UNITED STATES PATENT AND TRADEMARK OFFICE

APPLICATION NO.	FILING DATE	FIRST NAMED INVENTOR	ATTORNEY DOCKET NO.	CONFIRMATION NO.
10/649,420	08/27/2003	Tim Terakita	10251-001	5301

Office Action Summary

DETAILED ACTION

8. Claims 1,4-8,11-13,15-19,21-24, and 27-29 are rejected under 35 U.S.C. 102(b) as being anticipated by Swanger (U.S. Design Patent No. US D446629). Figures 2 and 6 from Swanger are found below and are used as references in the following rejections.

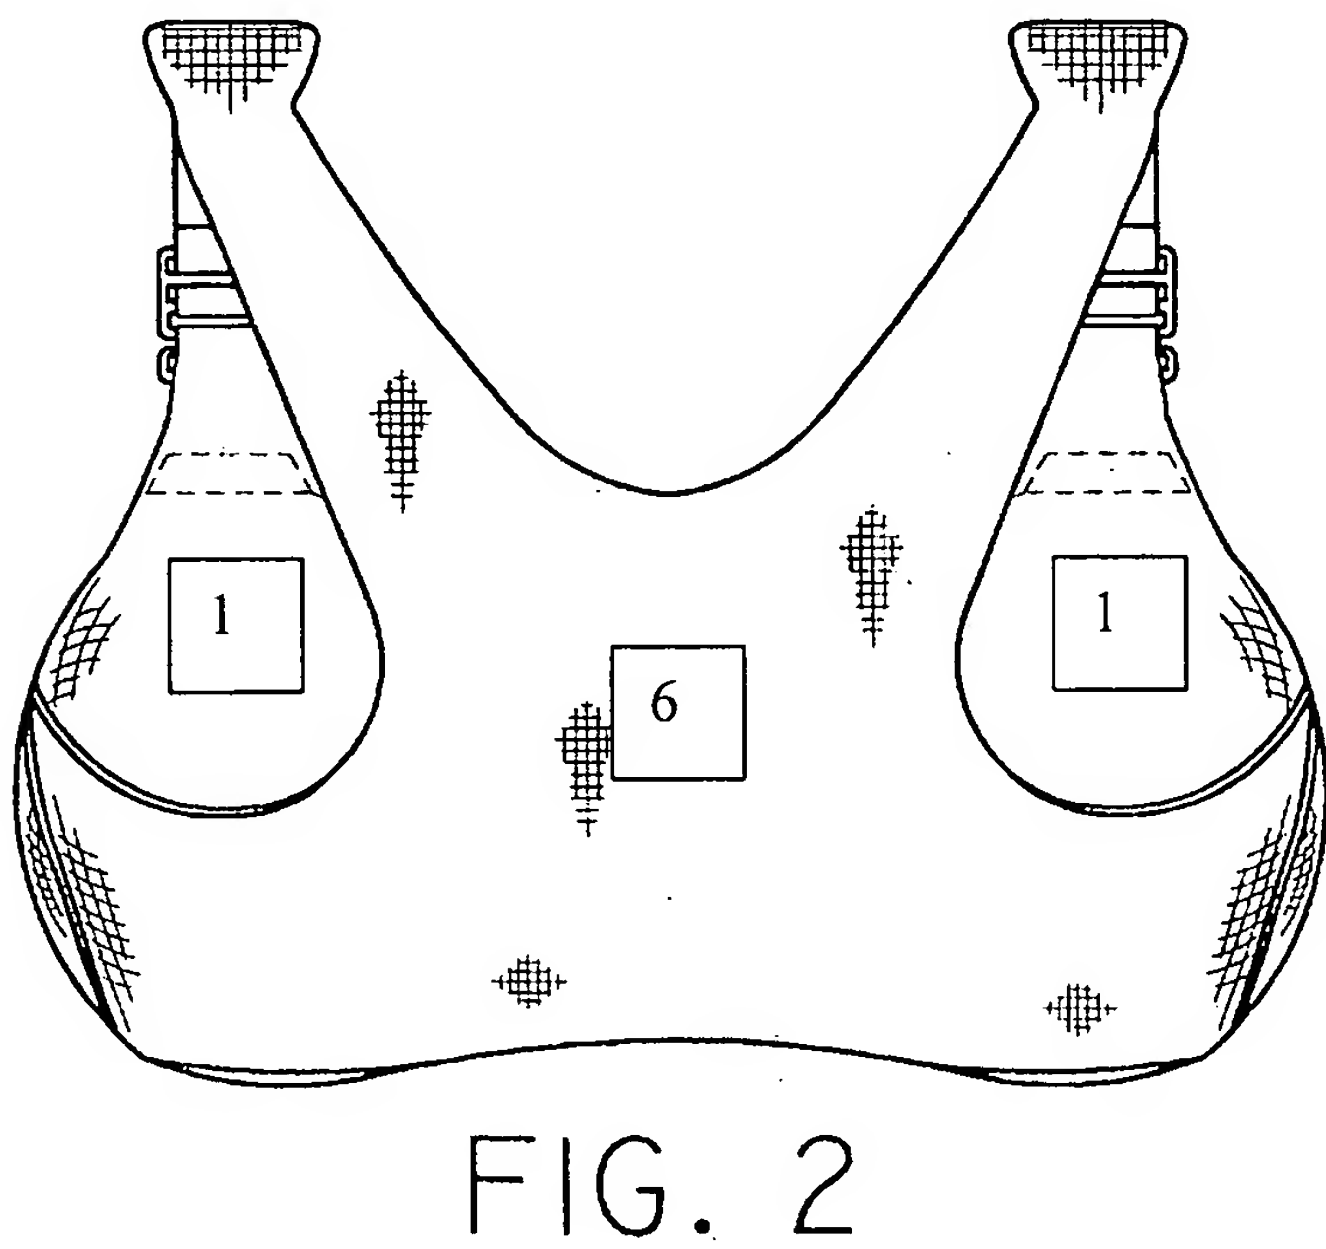
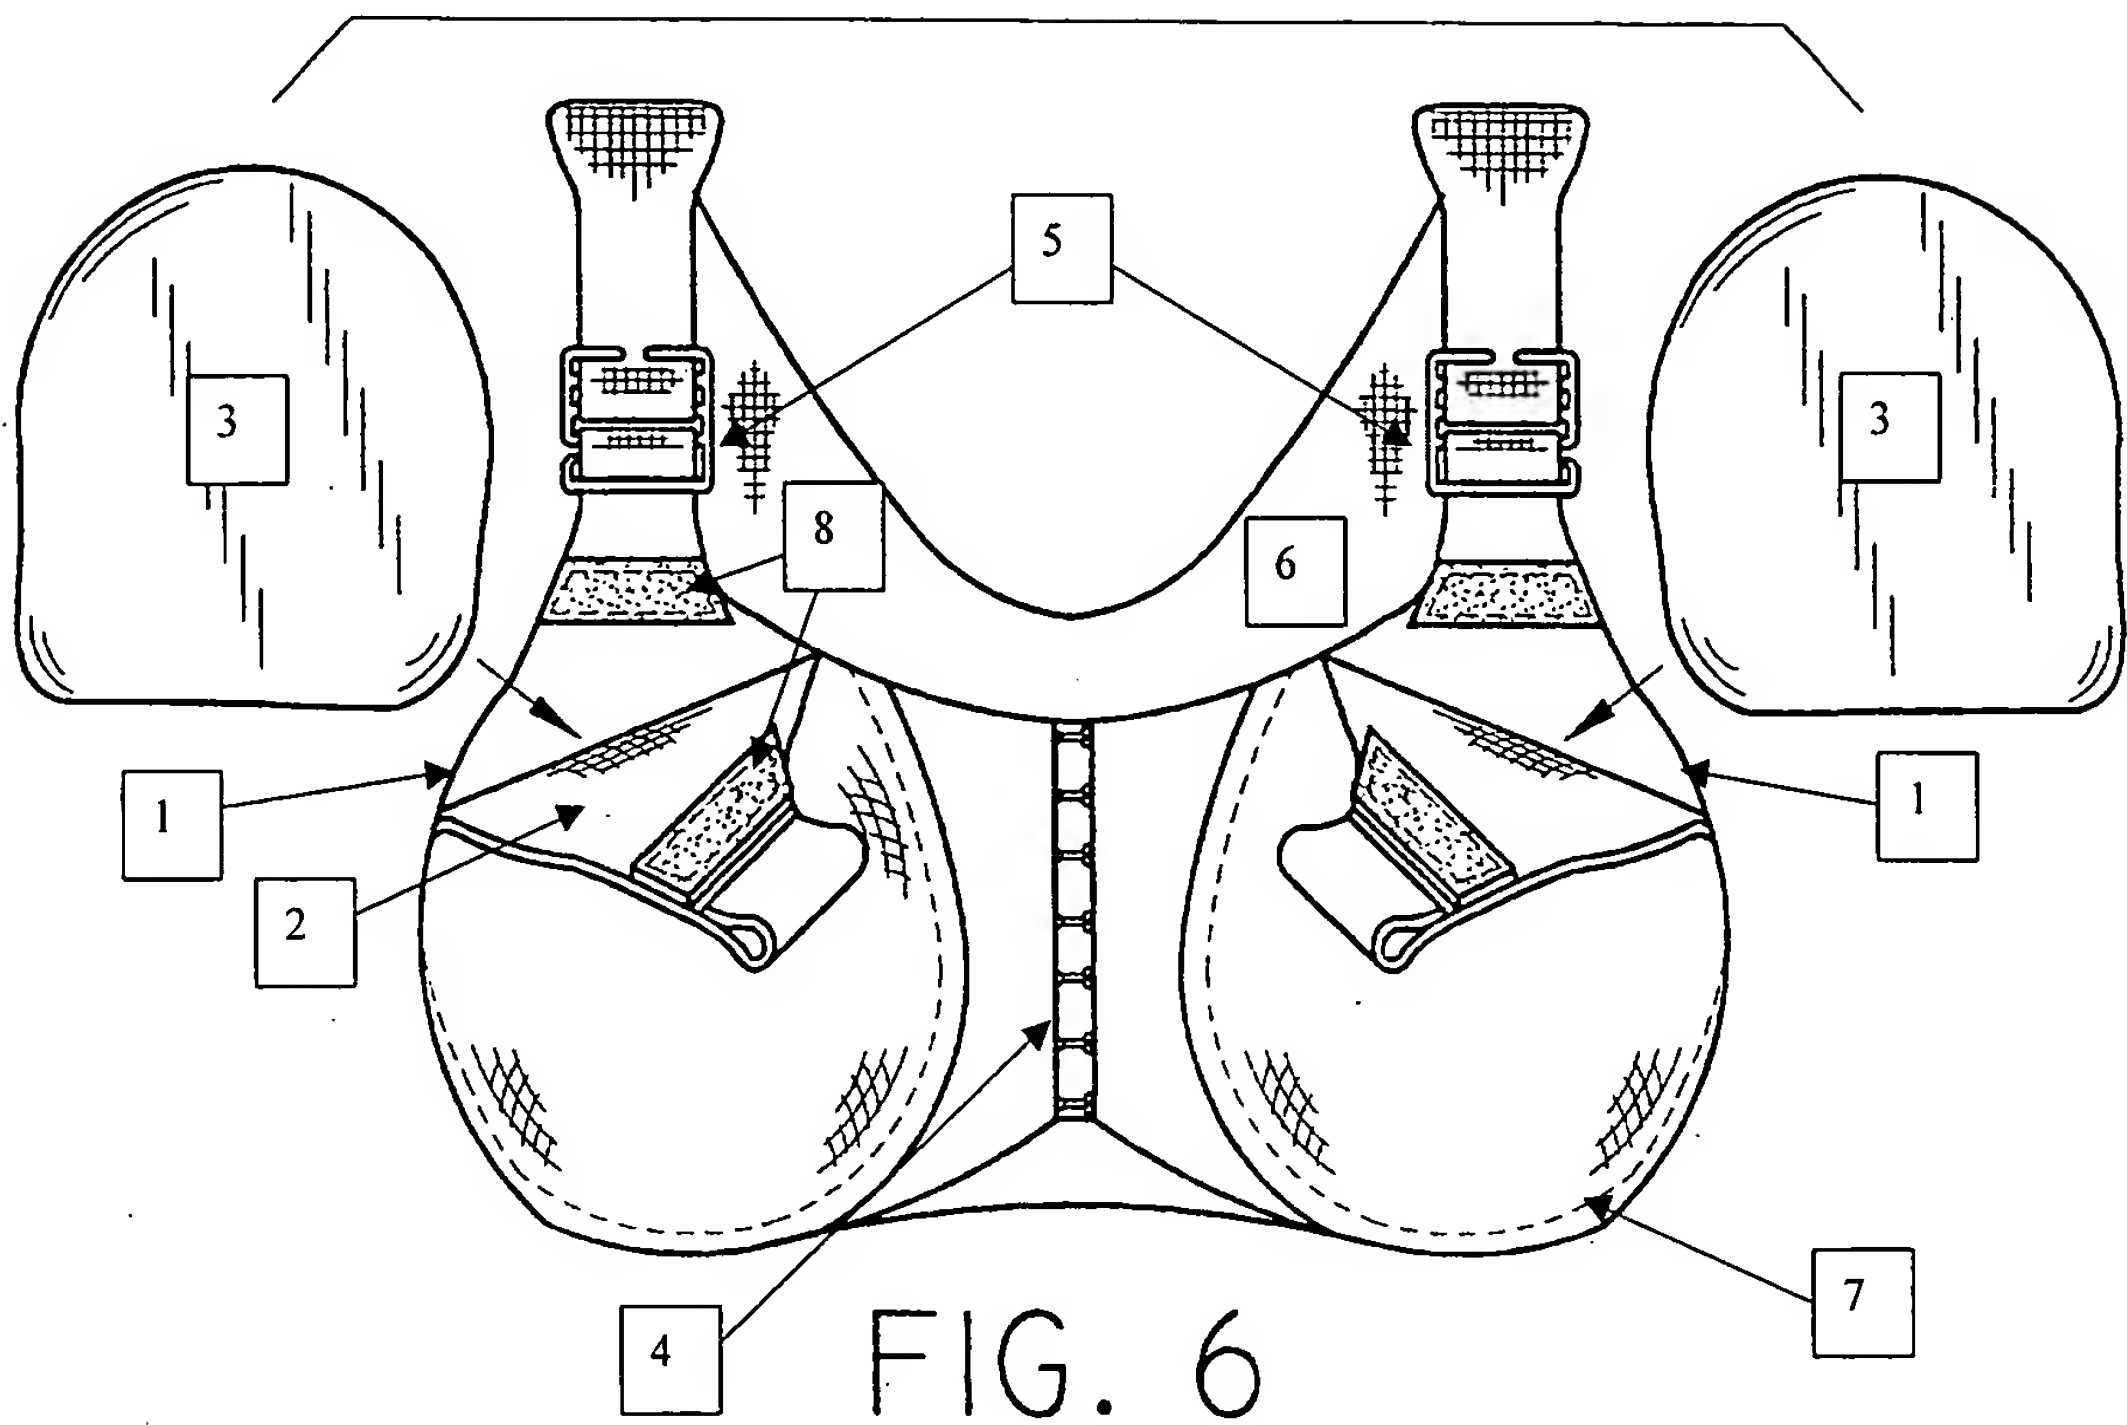
9. In regards to claim 1, Swanger discloses a therapeutic body covering comprising "a panel for covering a certain area of a body", (element 1), "a removable flap positioned over said panel", (element 2), "a therapeutic insert

configured to conform to said area of said body", (element 3), "a securing panel to hold said panel to said certain area of said body", (element 4), "wherein said panel and said securing panel are configured so that said certain area of said body is not moved when placing said therapeutic insert between and removing said therapeutic insert from said panel and said flap." (element 4).

13. In regards to claim 7, Swanger discloses "said certain area of said body comprises at least one of a knee area, a shoulder area, an elbow area, an ankle area, and a mammary gland area." (See Swanger Figure 6 below).

removable first flap positioned over said first front panel." (element 2), "a removable second flap positioned over said second front panel." (element 2), "a therapeutic insert." (element 3), "wherein said therapeutic insert is configured to conform to a breast size." (element 3), "wherein said first front panel, said second front panel, and said back panel are configured so that said breasts are not moved when placing said therapeutic insert between and removing said therapeutic insert from at least one of said first front panel with said first flap and said second front panel with said second flap." (See Swanger Figure 6 below).

16. In regards to claim 12, Swanger discloses "a first strap and a second strap wherein said first strap has a first end connected to said first panel and a second end connected to said back panel and said second strap has a first end connected to said second panel and a second end connected to said back panel" (See Swanger Figure 6 below).

18. In regards to claim 15, Swanger discloses "wherein at least one of said first panel and said second panel comprises two pieces of material wherein an opening is provided between said pieces of material for placement of said therapeutic insert" (See Swanger Figure 6 below, arrows drawn from element 3 show location of opening).

20. In regards to claim 17, Swanger discloses "a therapeutic bra for reducing movement of a breast when applying at least one of a cooling compress and a warming compress to said breast comprising a first bra cup covering a first breast" (element 1), "a second bra cup covering a second breast" (element 1), "a first bra cup flap removable from an outer edge of said first bra cup" (element 2), "a second bra cup flap removable from an outer edge of said second bra cup" (element 2), "a back strap having a first end connected to said first bra cup and a second end connected to said second bra cup" (element 6), "at least one of a cooling compress and a warming compress formed to a shape of at least one of said first breast and said second breast" (element 3), "wherein at least one of said cooling compress and said warming compress fits between at least one of said first bra cup flap connected to said first bra cup and said second bra cup flap connected to said second bra cup" (See Swanger Figure 6 below, arrows drawn from element 3 show location of opening).

25. In regards to claim 23, Swanger discloses "comprises a first strap having one end connected to said first bra cup and a second end connected to said back panel and a second strap having one end connected to said second bra cup and a second end connected to said back panel" (See Swanger Figure 2 below).

therapeutic insert" (See Swanger Figure 6 below, arrows drawn from element 3 show location of opening).
